APPLICATION AND FINAL PLAT CHECKLISTDate January 25, 1991Name of Proposed Development LOT 1, BLOCK 1, CROSSINGS ADDITIONName of Developer RACETRAC PETROLEUM, INC.Address 300 Technology Ct., Smyrna, Georgia Phone 1-800-877-7357Owner of Record 30080
RACETRAC PETROLEUM, INC.Address 300 Technology Ct., Smyrna, Georgia Phone 1-800-877-7357Name of Land ~~Owner~~ / Surveyor / ~~Engineer~~ 30080
Don E. Gossett, R.P.L.S.Address 1015 Yvonne Dr., Joshua, Tx. 76058 Phone 817-295-0733Total Acreage 1.004Current Zoning "C"Number of Lots / ~~Units~~ OneSigned Don E. Gossett

FINAL PLAT LOT 1, BLOCK 1 CROSSINGS ADDITION

RACETRAC SITE PLAN - SH 205 NORTH OF IH-30 AND LAKESIDE CHEVROLET

Agenda Item: P&Z 91-1-CUP/SP/FP - Hold Public Hearing and Consider Recommending Approval of a Request From Racetrac, Inc., for a Conditional use Permit for a Building Not Meeting Materials Requirements and Approval of a Site Plan and Final Plat for a Self Serve Gas Station Located on SH-205 North of I-30

3 FRONT ELEVATION
A-2 1/4"=1'-0"

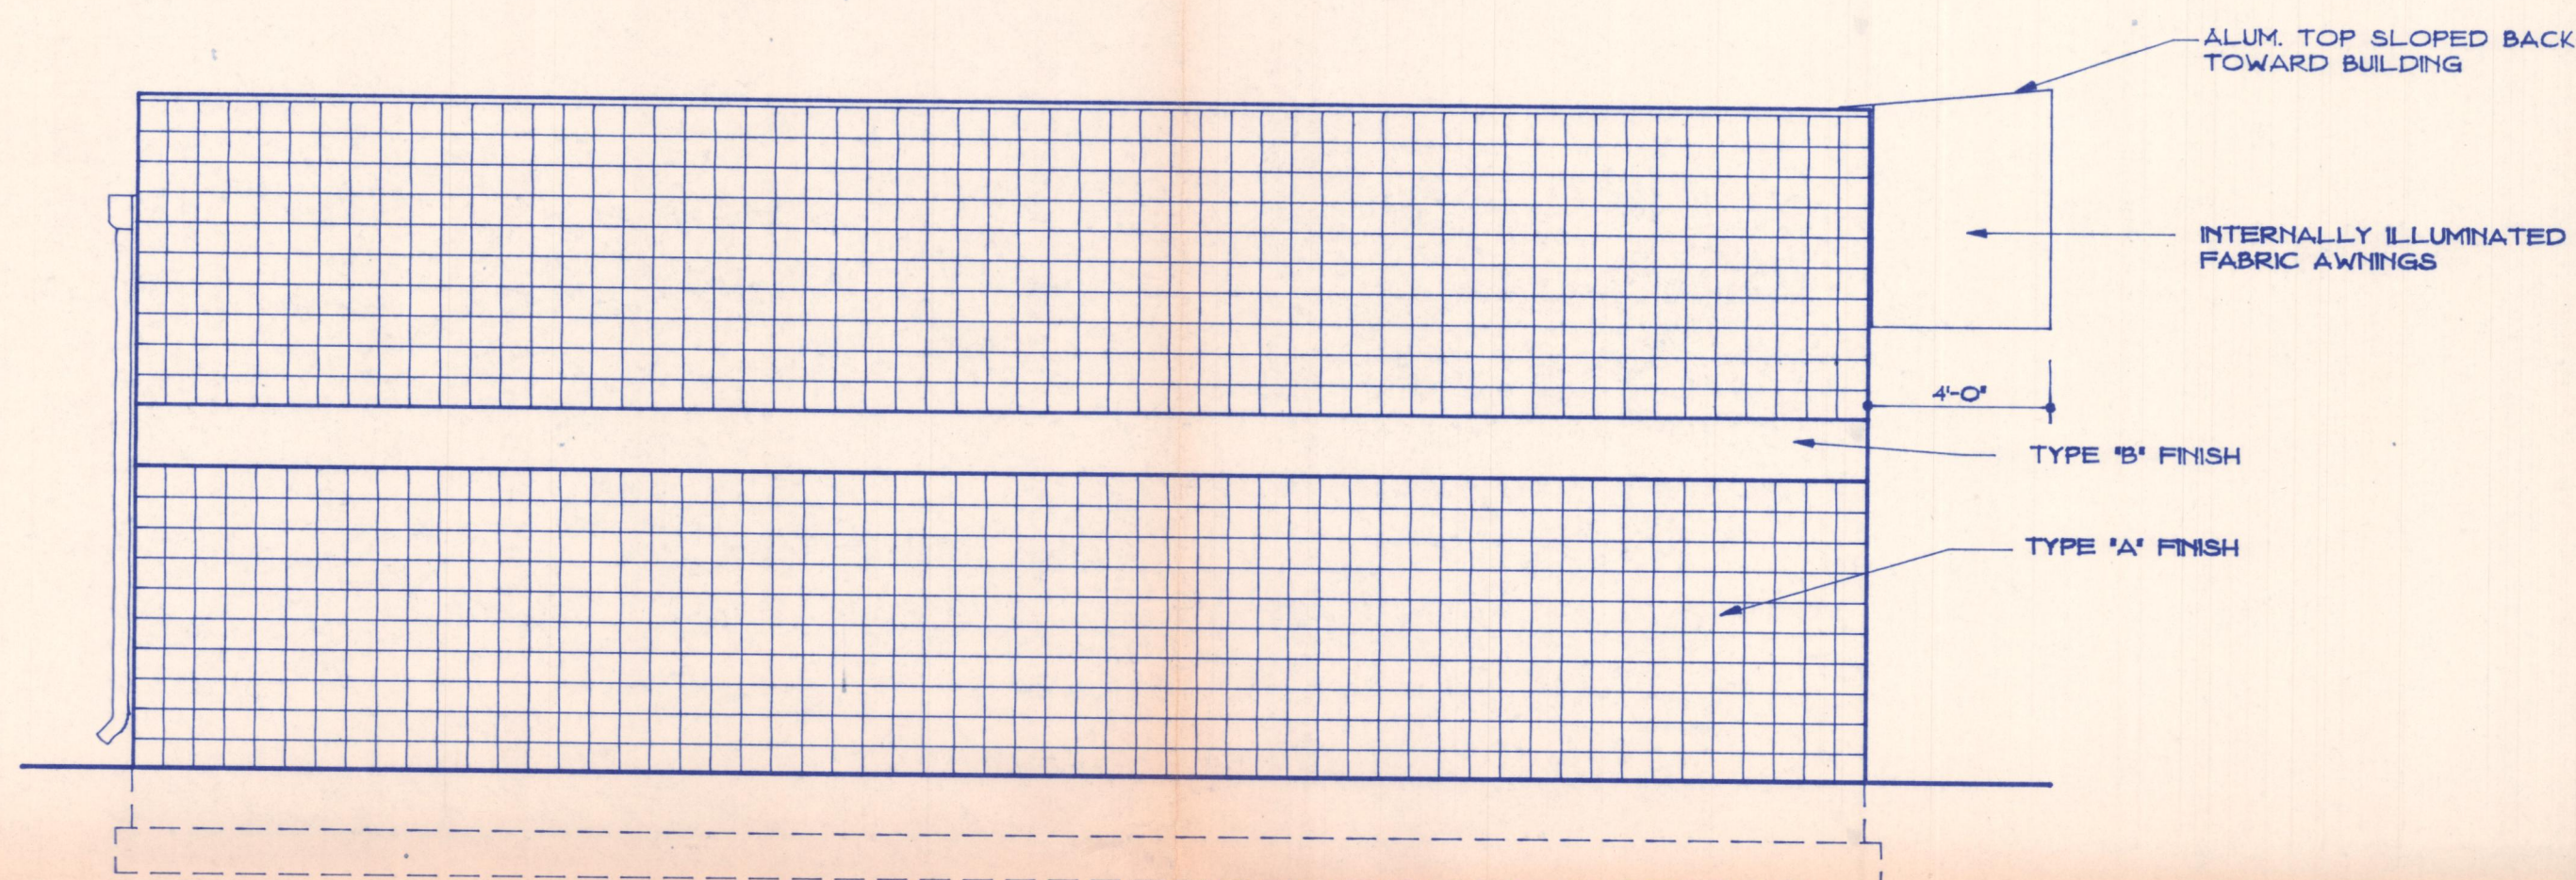
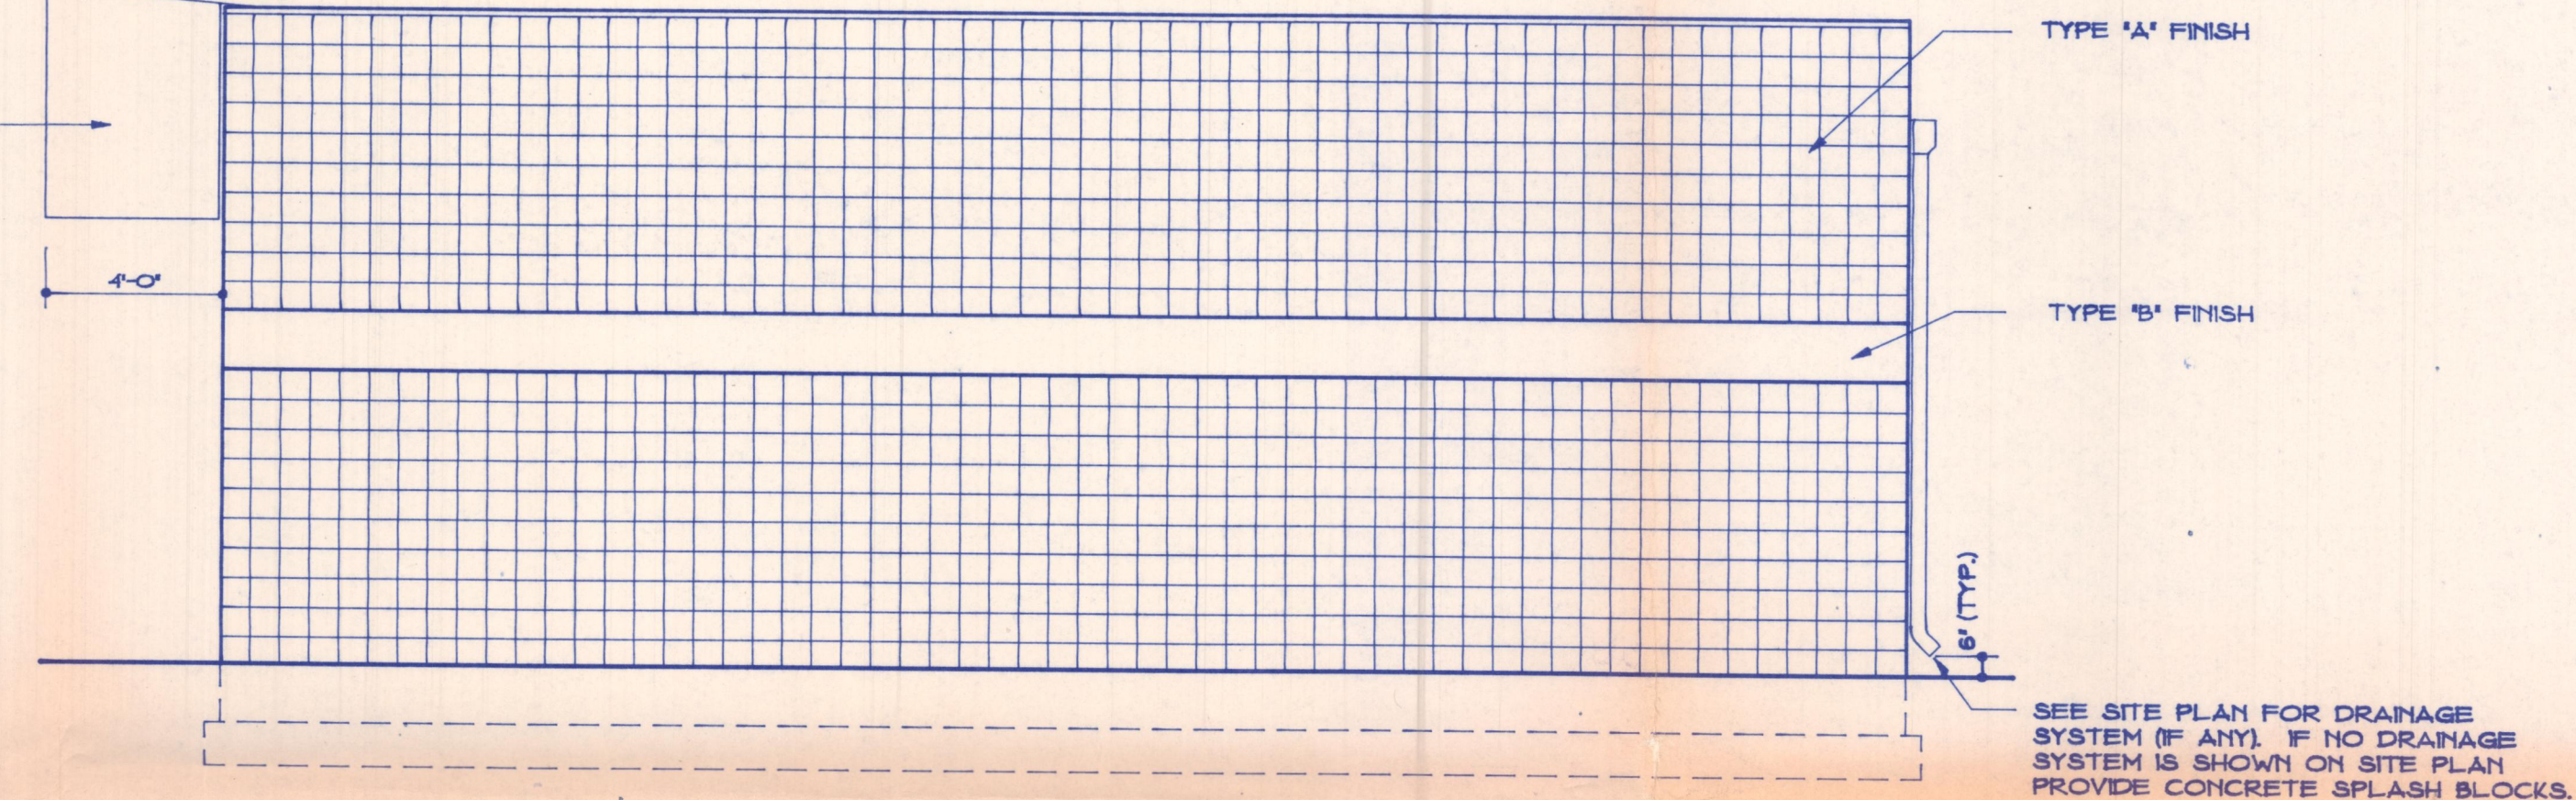
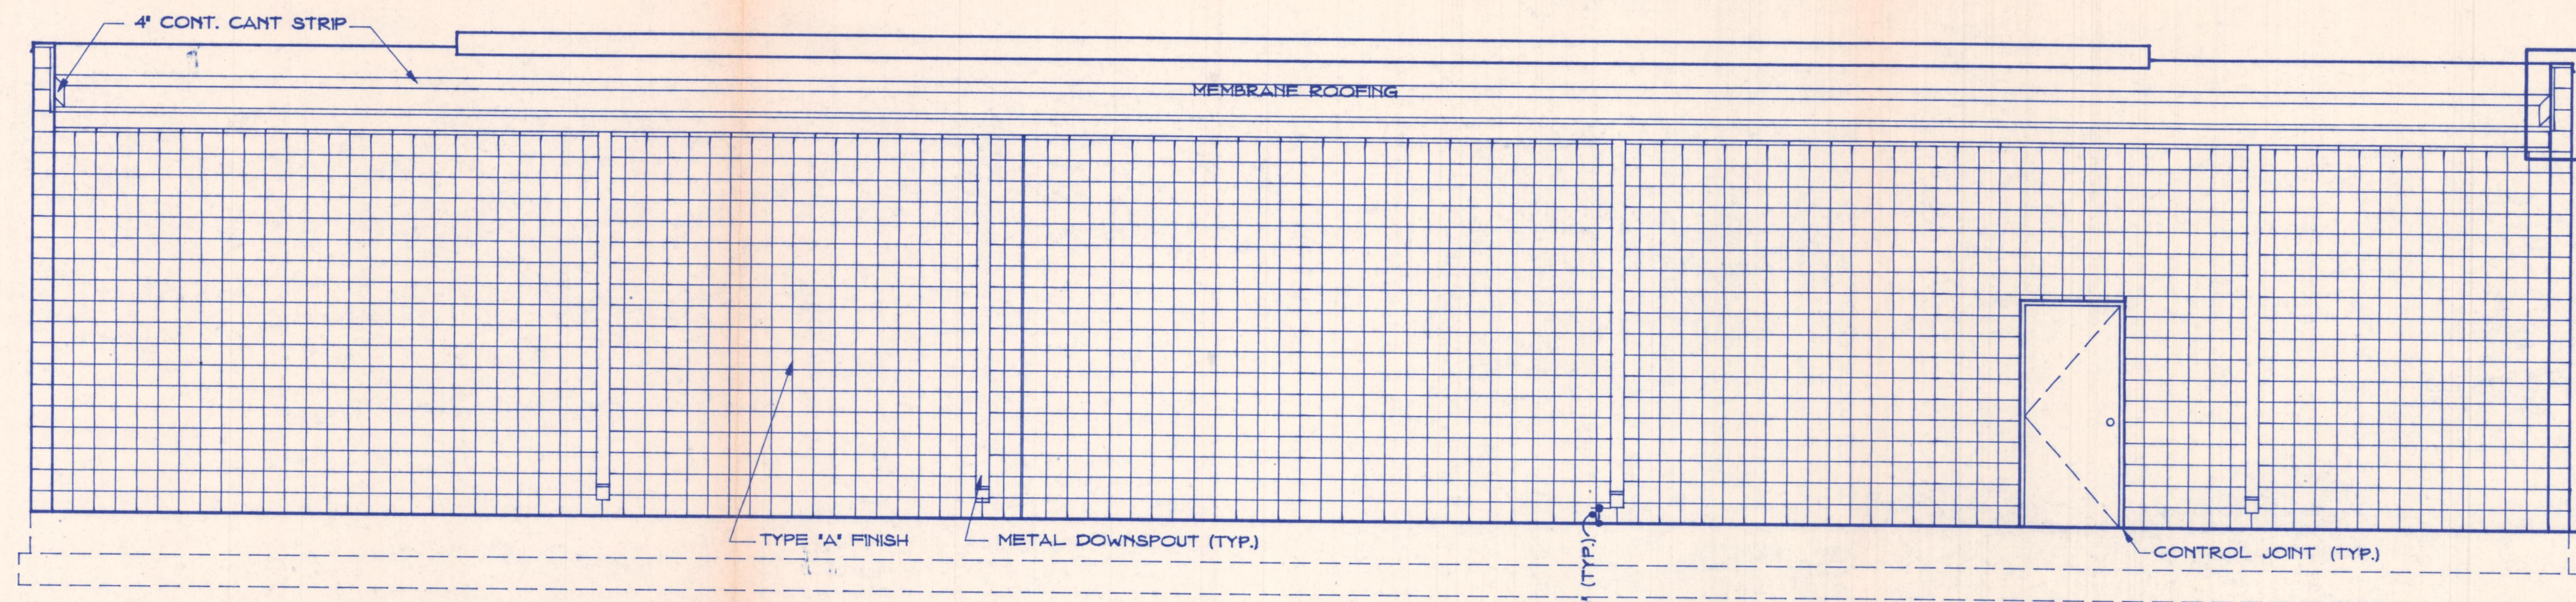
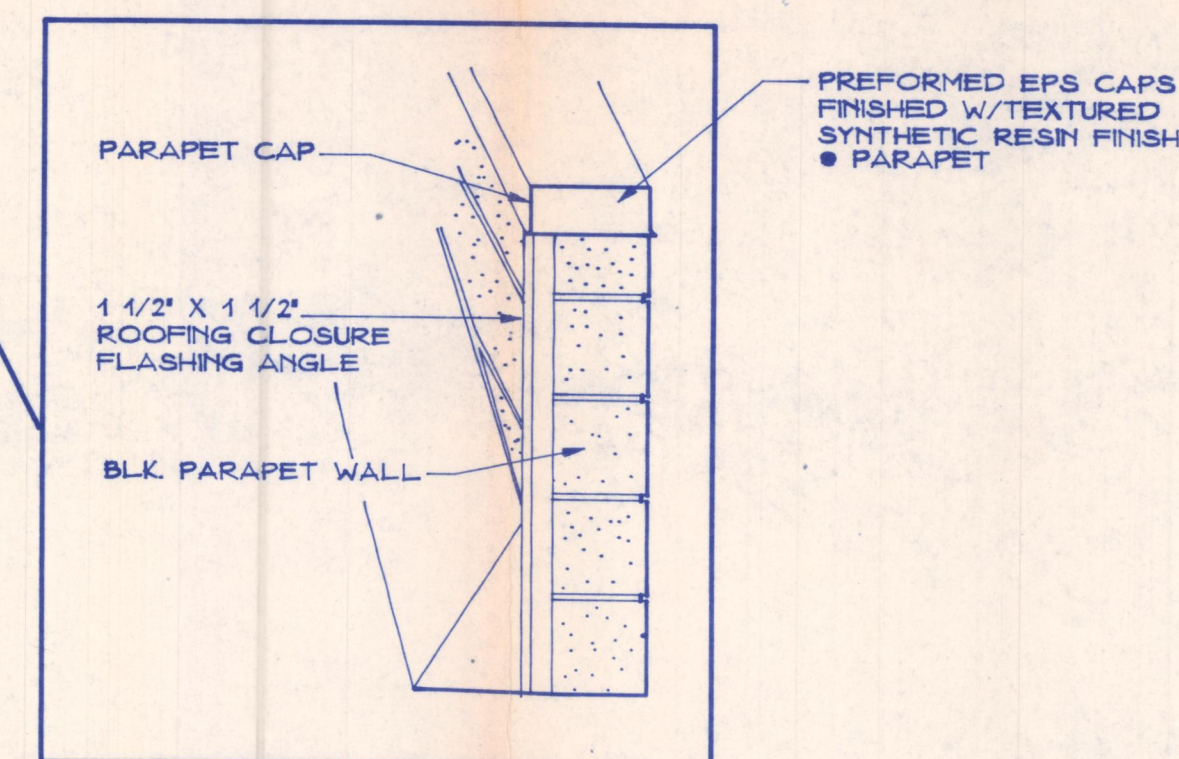
Building - the building is proposed to be constructed out of a concrete block material. This is very similar to the material used by Braum's for their building. This material does require a CUP to be used. They do not show a parapet wall along the back of the building but they are willing to put a wall along the rear. This should be included as a condition in the approval.

Canopy supports and sign support - They plan to use a stucco material to screen the metal supports for both the sign and canopy rather than brick. The stucco would be painted grey to match the building.

The Commission recommended approval of the site plan with the conditions that a parapet wall be constructed along the back of the building to match the other walls, and that the canopy supports and the sign pole be wrapped with the split face block to match the material used on the main structure.
